**Subject: Addendum to the Final Status Survey Plan for Section 2 of the
Whittaker Corporation Waste and Slag Storage Area
EnergySolutions Document No. 82A9564, Revision 3**

ADDENDUM AUTHORIZATION

Document Title: Final Status Survey Plan – Section 2 of the Whittaker Site Document No. 82A9564, Rev. 3
Addendum No.: 1 Originator Kevin E. Taylor
For Site/Utility: Whittaker Site, Greenville, PA

ADDENDUM 1**FINAL STATUS SURVEY PLAN (FSSP)****SECTION 2 OF THE WHITTAKER CORPORATION
WASTE AND SLAG STORAGE AREA
REYNOLDS INDUSTRIAL PARK
TRANSFER, PENNSYLVANIA****ENERGYSOLUTIONS DOCUMENT NO. 82A9564, REVISION 3**

Figure 2-1
Whittaker Section 2 Pit Area - Samples Collected on July 7, 2006

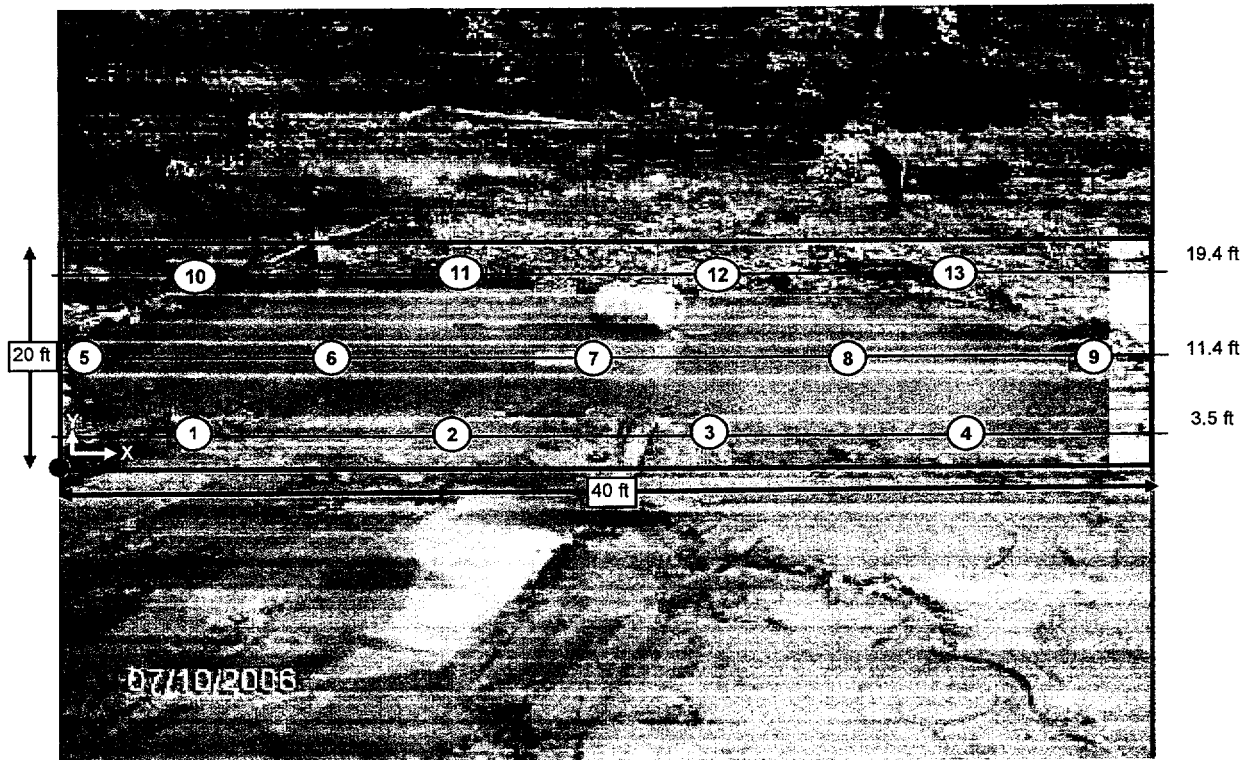
The pit area will be sampled using a random-start systematic triangular sampling pattern. As described in the FSS, a minimum of eleven samples will be collected from the area. The samples will be collected using clean sampling tools and dried.

Figure 2-1 provides the layout of the sample locations.
